POLLUTION ABATEMENT SERVICES
IMPROVEMENT SUGGESTED FOR IMMEDIATE CONSTRUCTION
(CONTRACT DOCUMENTS TO BE PREPARED
BY URS CONSULTANT UNDER TASK-5
OF O&M CONTRACT)

RE: Pollution Abatement Services (PAS)
Oswego County, Site #7-38-001

RE: PAS SITE O&M SITE NO. 7-38-001 (W.A. D002340-8)

RE: Pollution Abatement Services O&M
Interim Plan to Lower Leachate Levels, and
Evaluation of Leachate Collection System and Containment Cell Cap

SOURCE OF THIS DRAWING
 RECORD DRAWINGS
 3/10/1988

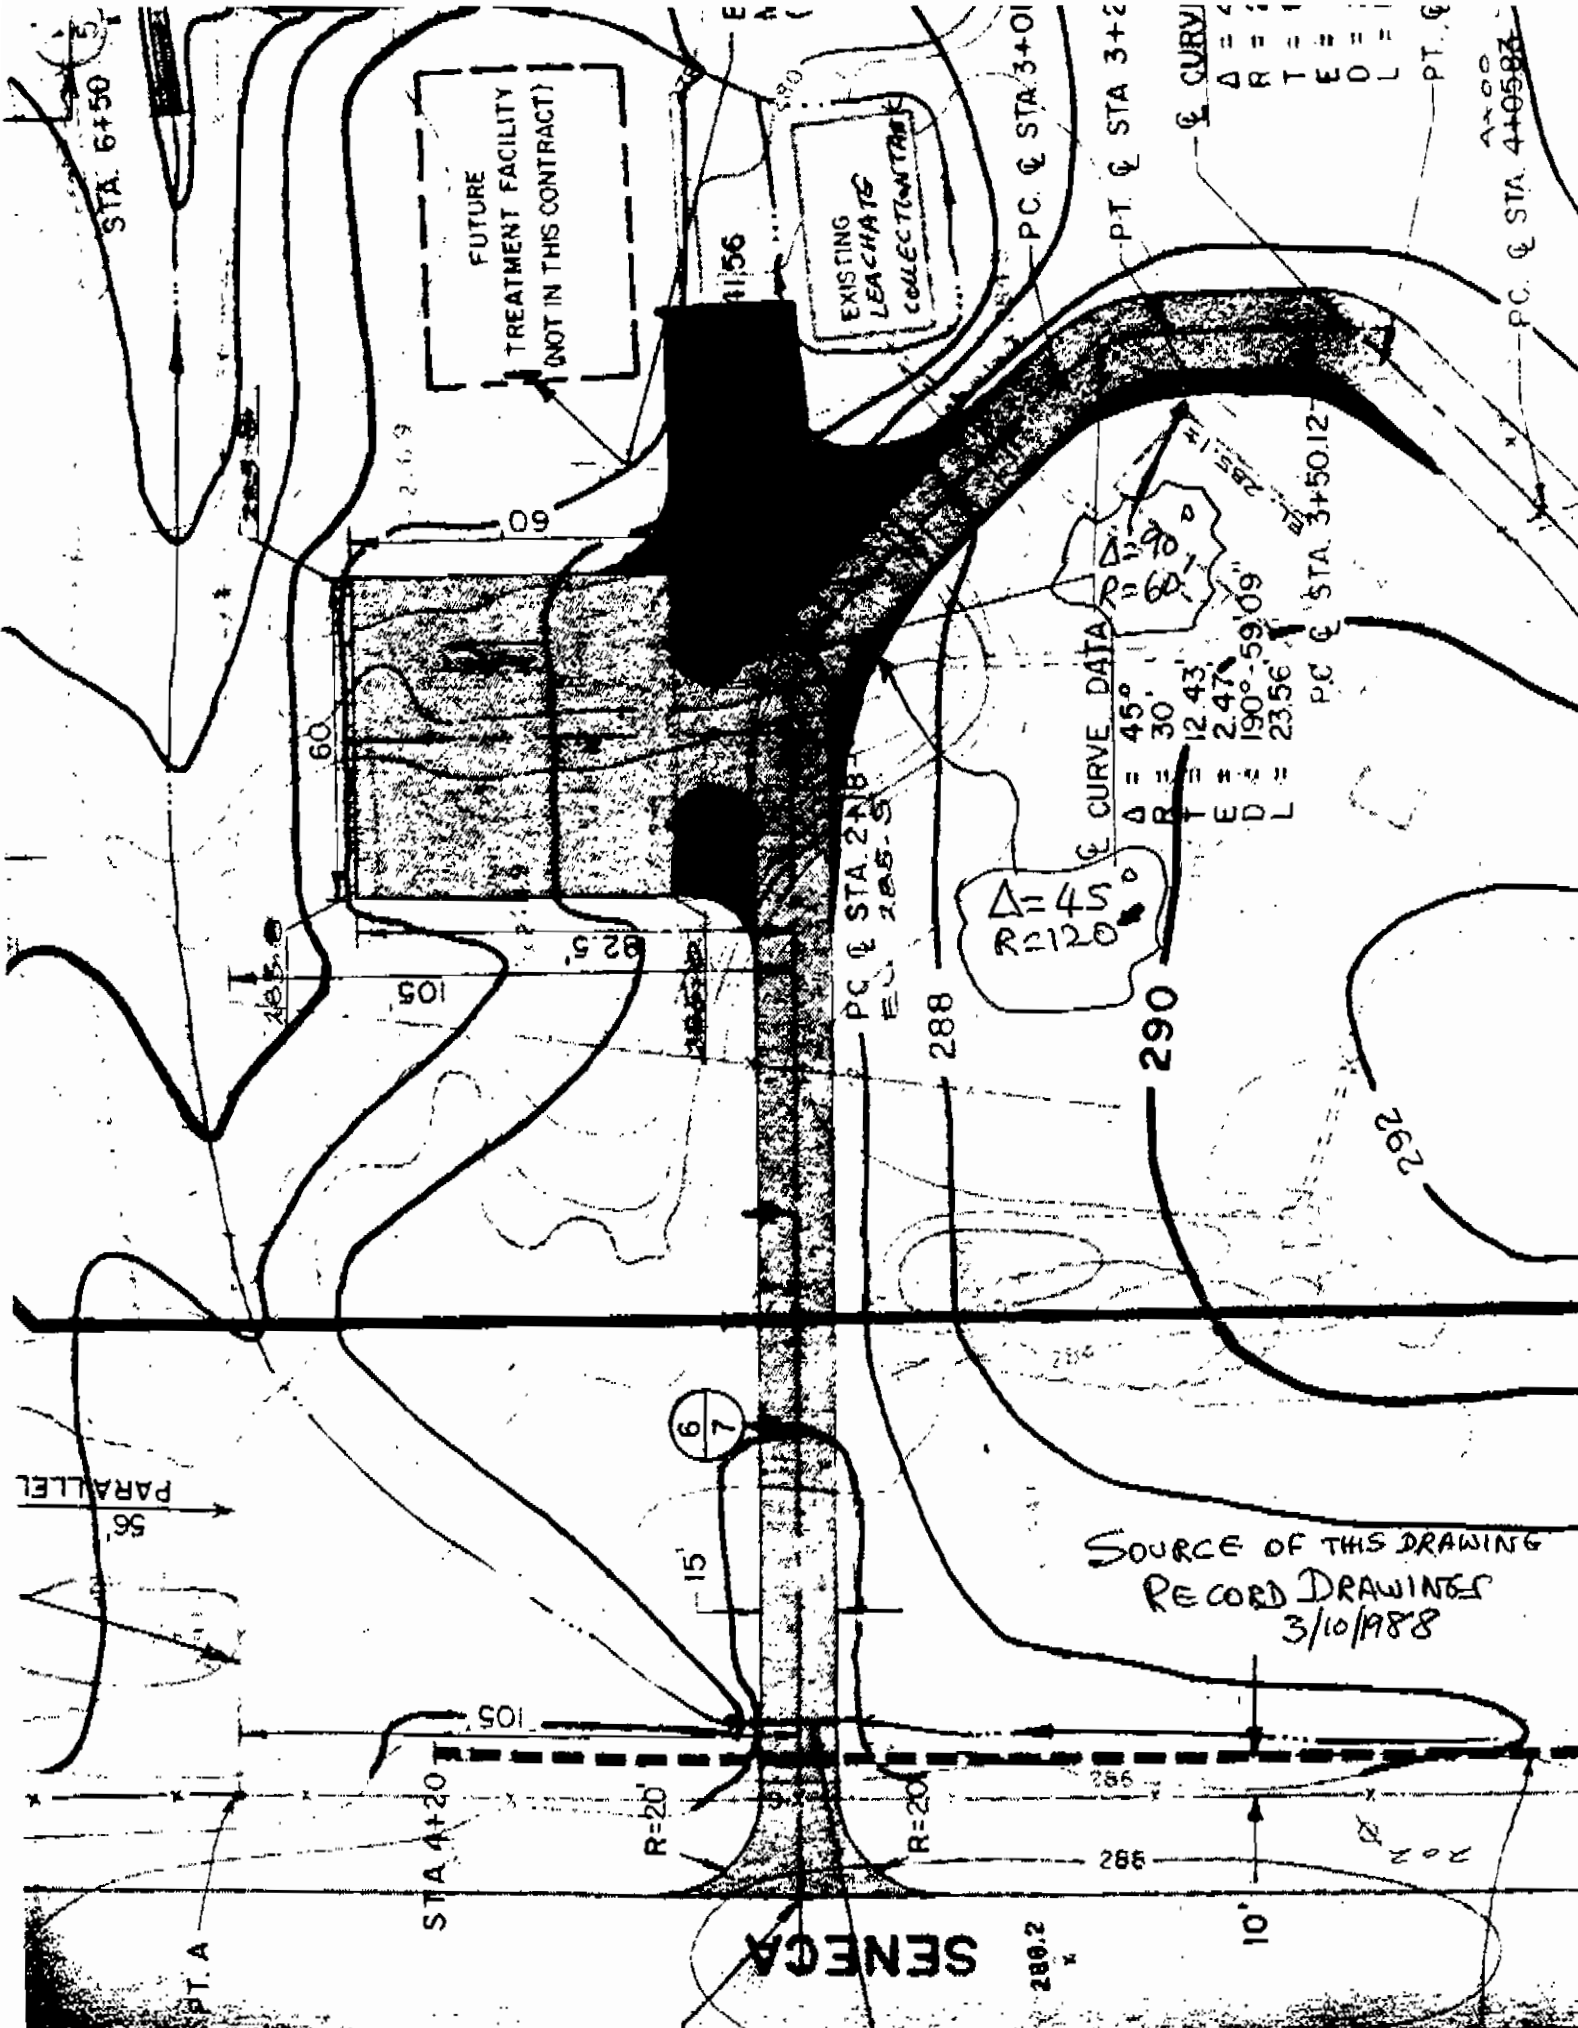
1. Construct 50' x 20' ^{contained} decon and leachate loading platform as shown on attached drawing.
2. Modify access road and parking area as shown.

NO by AKG

SOURCE OF THIS DRAWING
 RECORD DRAWINGS
 3/10/1988

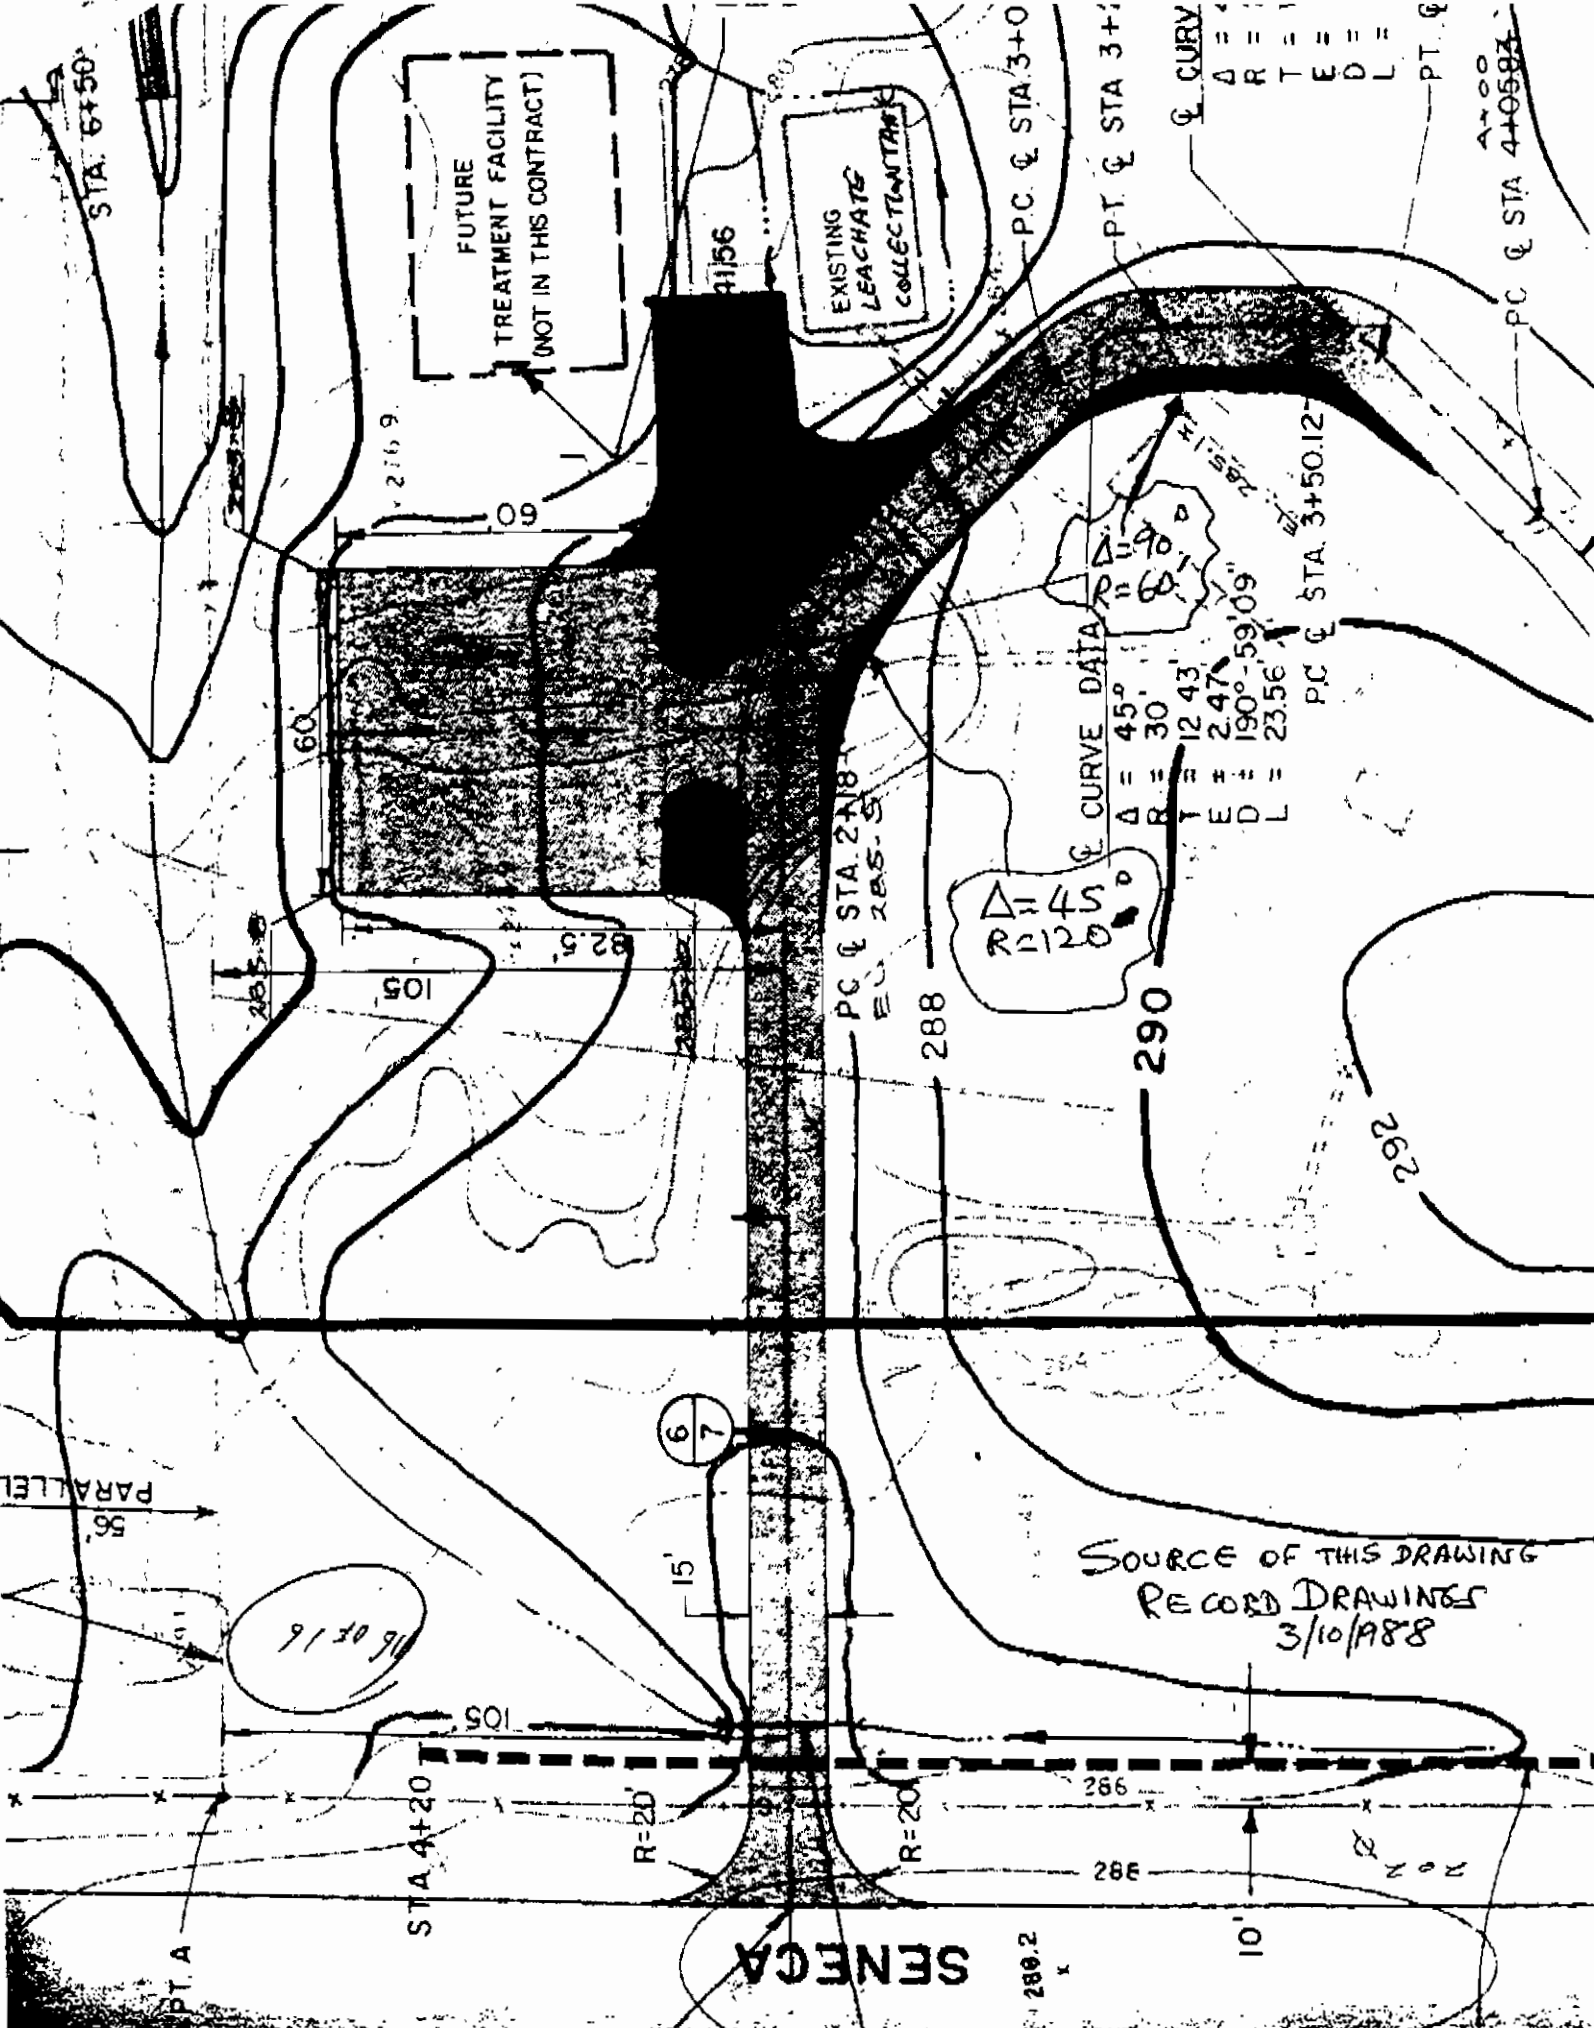
1. Construct 50' x 20' ^{contained} decon and leachate loading platform as shown on attached drawing.
2. Modify access road and parking area as shown.

1. **Loading Platform:** Remove topsoil, build asphalt pad with drain to collection tank, and fill.
2. **Widen Road:** Widen road in areas shown on attached sketch.

SOURCE OF THIS DRAWING
RECORD DRAWING
3/10/1988

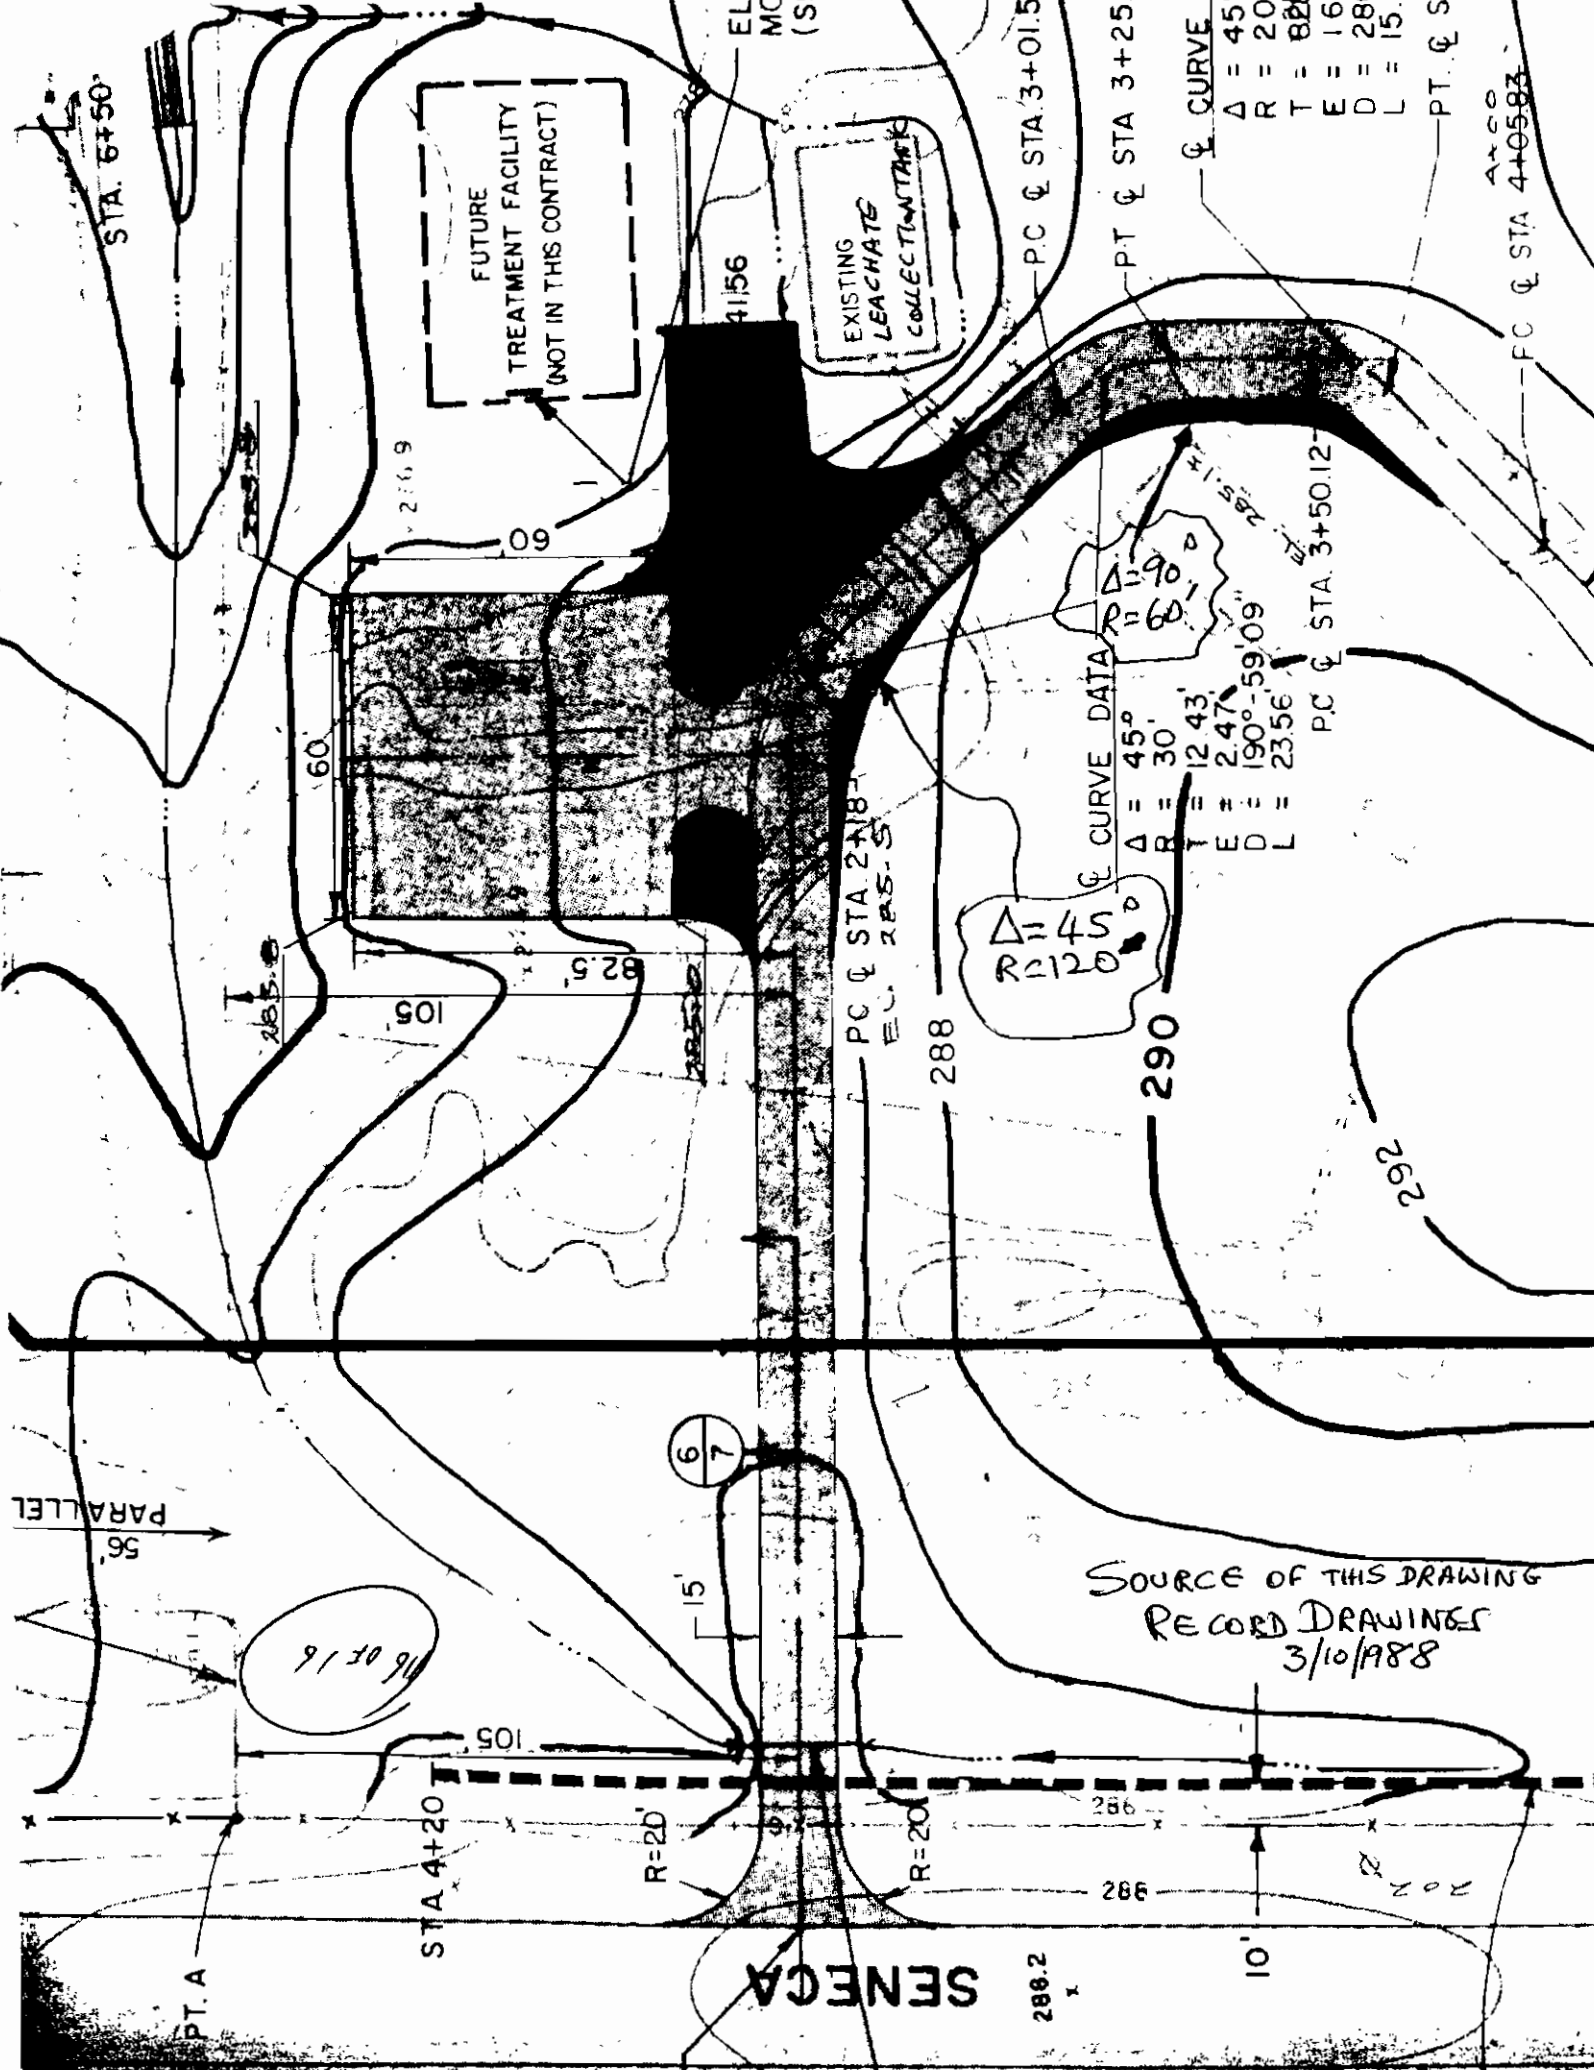
16. Appendix F. See comment # 7 above.
17. Appendix I. The area between the pavement in front of the storage shed and the access road should be squared off for ease of snow plowing (see attached drawing).

1. **Loading Platform:** Remove topsoil, build asphalt pad with drain to collection tank, and fill.
2. **Widen Road:** Widen road in areas shown on attached sketch.
